# Access Compliance Report

## Public Rights-of-Way

### (Curb Ramps)

Intersection ID: 49235	Main Street: NEW_CALVINE_ST	Cross Street: N_CALDWELL_ST	Location: N
ADA ID: 93035114055F	Ramp Type: Perp	Initial Pass/Fail: Fail	Overall Compliance: No
Severity Score: 13.75			
Codes/Mitigation Info/Possible Solution		Field Measurements/Component Compliance

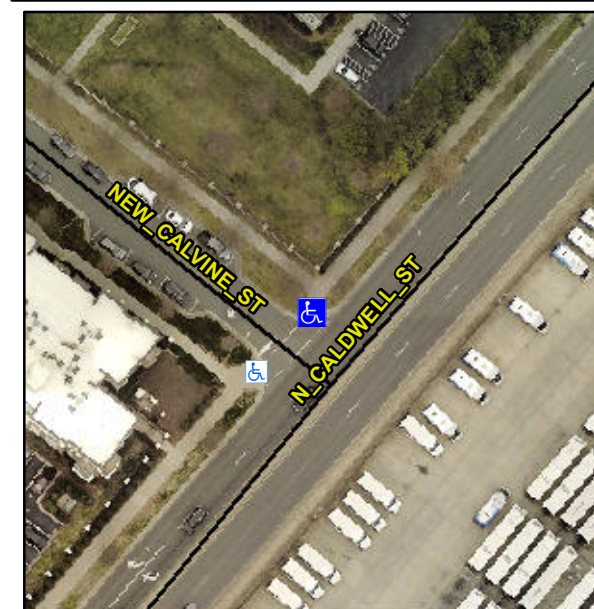
**Not Found, R304.2.2, R304.5.3**

Compliance	Description	Data	Compliance	Description	Data
N/A	Ramp Length (in)	73.0	No	Ramp Slope (%)	9.1
Yes	Ramp Width (in)	48.0	No	Ramp XSlope (%)	2.6
N/A	Flare Type LT	N/A	N/A	Flare Type RT	N/A
N/A	Flare Slope LT (%)	N/A	N/A	Flare Slope RT (%)	N/A
N/A	Flare Traversable LT?	N/A	N/A	Flare Traversable RT?	N/A
N/A	Landing Length (in)	N/A	N/A	DWS Provided?	N/A
N/A	Landing Width (in)	N/A	N/A	DWS Contrast?	N/A
N/A	Landing Slope (%)	N/A	N/A	DWS Length (in)	N/A
N/A	Landing X Slope (%)	N/A	N/A	DWS Full Width?	N/A
N/A	Landing Curb? (Y/N)	N/A	N/A	DWS Offset (in)	N/A
N/A	Shared Landing?	N/A			
N/A	Gutter Ponding?	N/A	N/A	Gutter Slope (%)	N/A
N/A	Gutter Lip Ht (in)	N/A	N/A	Gutter X Slope (%)	N/A
N/A	Painted X Walk1?	Yes	N/A	Painted X Walk2?	N/A
	X Walk 1 Direction	To SW		X Walk 2 Direction	N/A
N/A	X Walk 1 Width (in)	108.0	N/A	X Walk 2 Width (in)	N/A
	X Walk 1 Slope (%)	0.6		X Walk 2 Slope (%)	N/A
	X Walk 1 X Slope (%)	5.1		X Walk 2 X Slope (%)	N/A

**Remove & Replace Entire Ramp.**
